Access Compliance Report

Public Rights-of-Way

(Curb Ramps)

Intersection ID: 45184	Main Street: HOLDEN_CT	Cross Street: TORRELLE_DR	Location: NW
ADA ID: 6693A95B3E3D	Ramp Type: PerpDiag	Initial Pass/Fail: Fail	Overall Compliance: No
Codes/Mitigation Info/Possible Solution		Field Measurements/Component Compliance	
Severity Score: 21.25

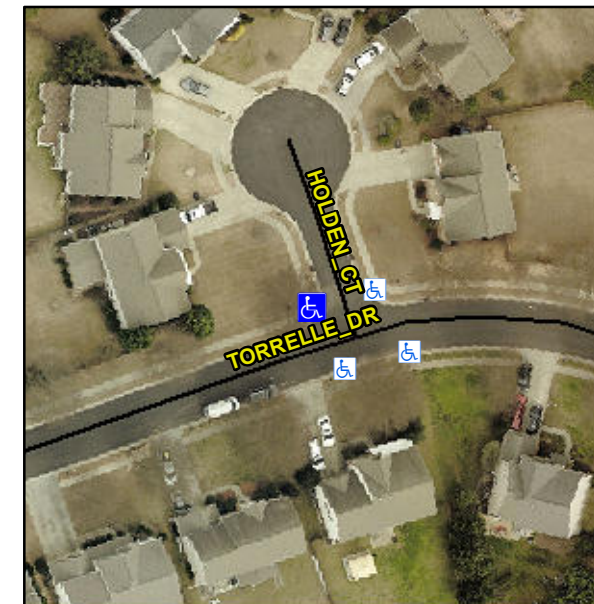
Remove & Replace Curb Ramp With Two New Directional Ramps or Equivalent.

Not Found, R304.5.1, R304.5.3

Compliance	Description	Data	Compliance	Description	Data
N/A	Ramp Length (in)	46.0	Yes	Ramp Slope (%)	7.2
No	Ramp Width (in)	45.5	No	Ramp XSlope (%)	5.1
N/A	Flare Type LT	N/A	N/A	Flare Type RT	N/A
N/A	Flare Slope LT (%)	N/A	N/A	Flare Slope RT (%)	N/A
N/A	Flare Traversable LT?	N/A	N/A	Flare Traversable RT?	N/A
N/A	Landing Length (in)	N/A	N/A	DWS Provided?	N/A
N/A	Landing Width (in)	N/A	N/A	DWS Contrast?	N/A
N/A	Landing Slope (%)	N/A	N/A	DWS Length (in)	N/A
N/A	Landing X Slope (%)	N/A	N/A	DWS Full Width?	N/A
N/A	Landing Curb? (Y/N)	N/A	N/A	DWS Offset (in)	N/A
N/A	Shared Landing?	N/A			
N/A	Gutter Ponding?	N/A	N/A	Gutter Slope (%)	N/A
N/A	Gutter Lip Ht (in)	N/A	N/A	Gutter X Slope (%)	N/A
N/A	Painted X Walk1?	No	N/A	Painted X Walk2?	No
	X Walk 1 Direction	To S		X Walk 2 Direction	To E
N/A	X Walk 1 Width (in)	N/A	N/A	X Walk 2 Width (in)	N/A
	X Walk 1 Slope (%)	1.6		X Walk 2 Slope (%)	0.0
	X Walk 1 X Slope (%)	0.6		X Walk 2 X Slope (%)	0.4
